RNP Instrument Approach Procedures at Sherburn-in- Elmet aerodrome

*Description of Airspace Change Proposal
For ACP-2015-04*

March 2022 version

Sherburn Aero Club Ltd

5.3 VFR chart 1:500,000 scale view Runway 28 approach

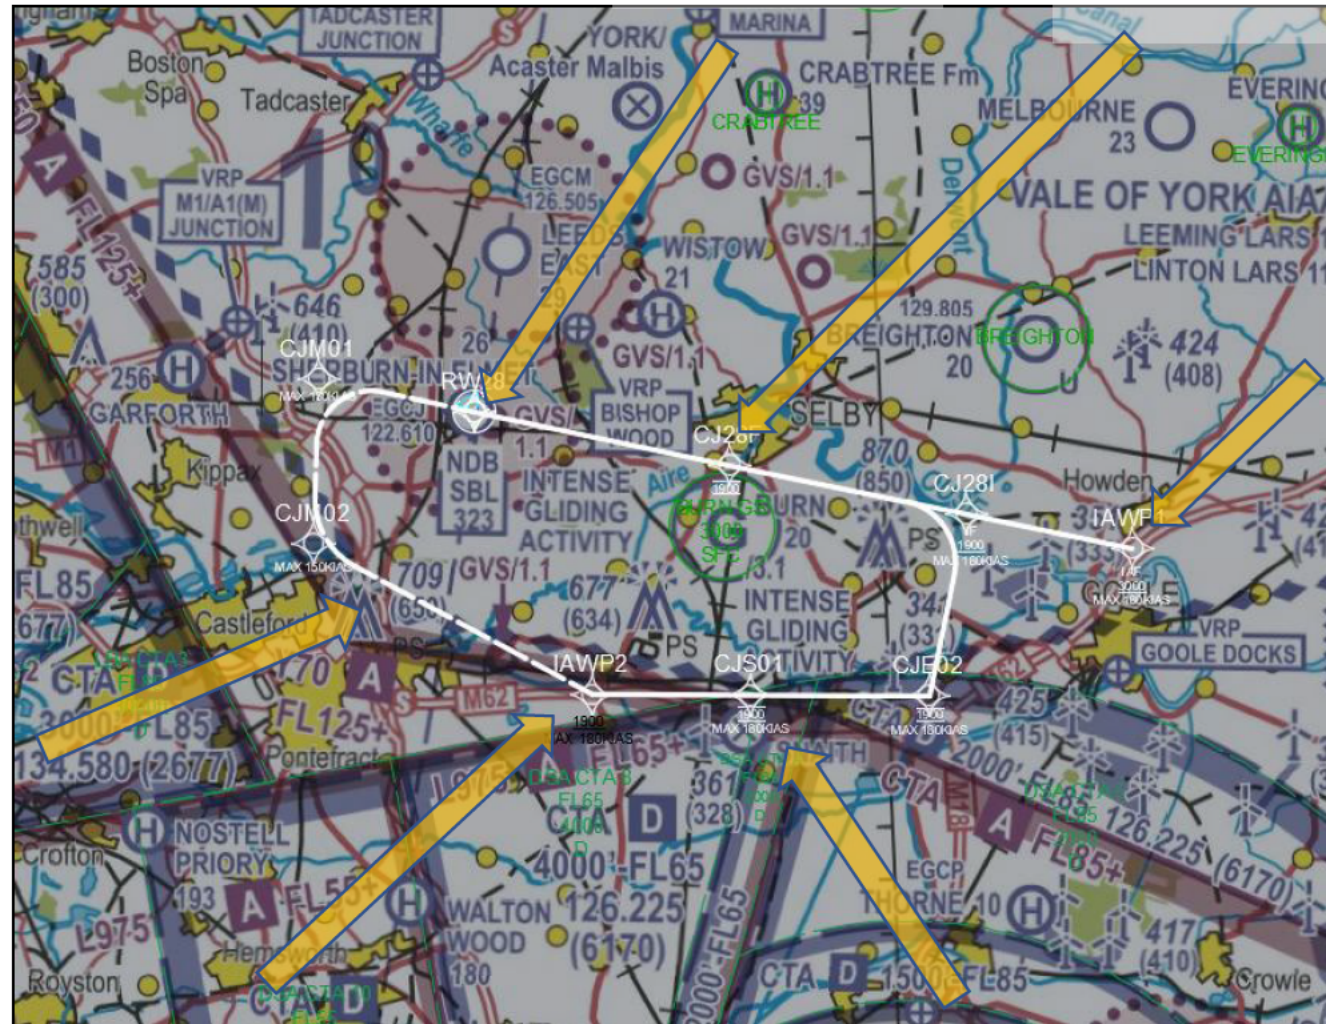
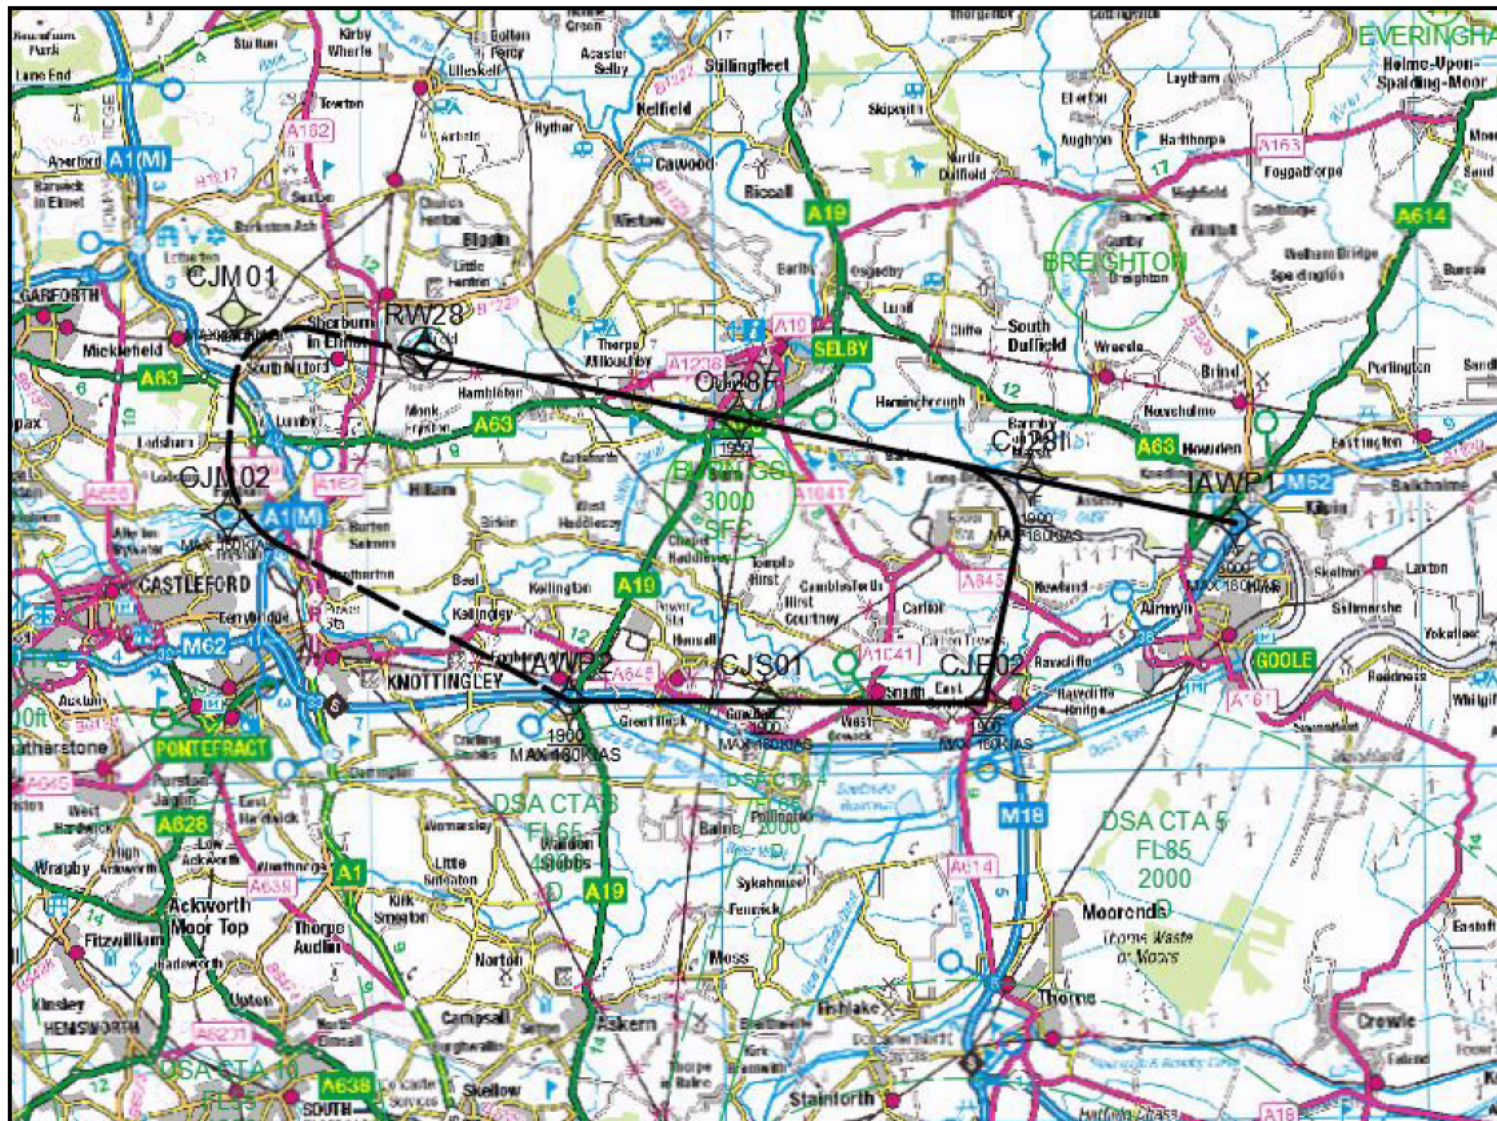
Final approach fix at altitude 1900 ft

Missed approach path (dashed line) is largely unchanged from earlier proposal, however it now terminates at the southern joining fix.

Northern joining point (Initial Approach Fix) now on the extended centerline. Altitude 3000 ft or above.

Southern joining point (Initial Approach Fix) Aircraft joining from the south will now join at this point and make a right turn to join the approach. Altitude 1900 ft or above.

Aircraft transitioning to the final approach will fly via this **intermediate point**, below the CTA (controlled airspace at Doncaster airport). Aircraft must descend to 1900 ft and cross this point at 1900 ft, unless cleared to transit higher by Doncaster ATC.

5.6 Runway 10 – draft Instrument approach chart

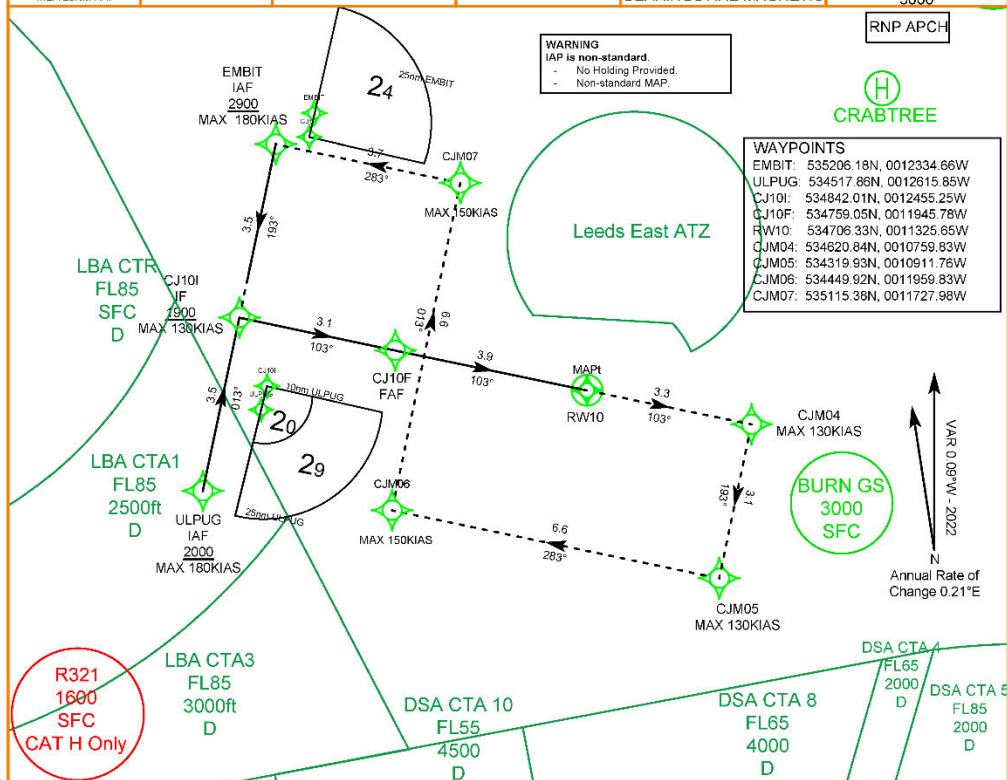
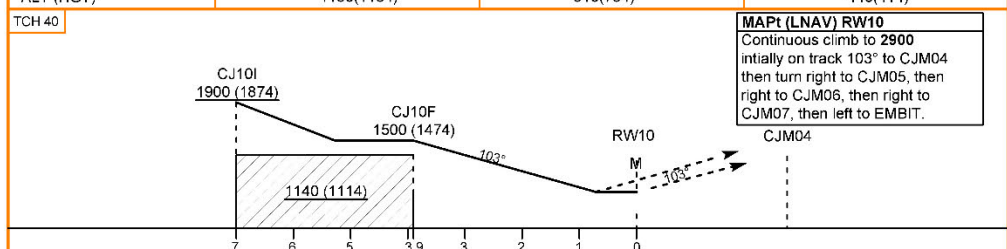
Changes : New Chart.
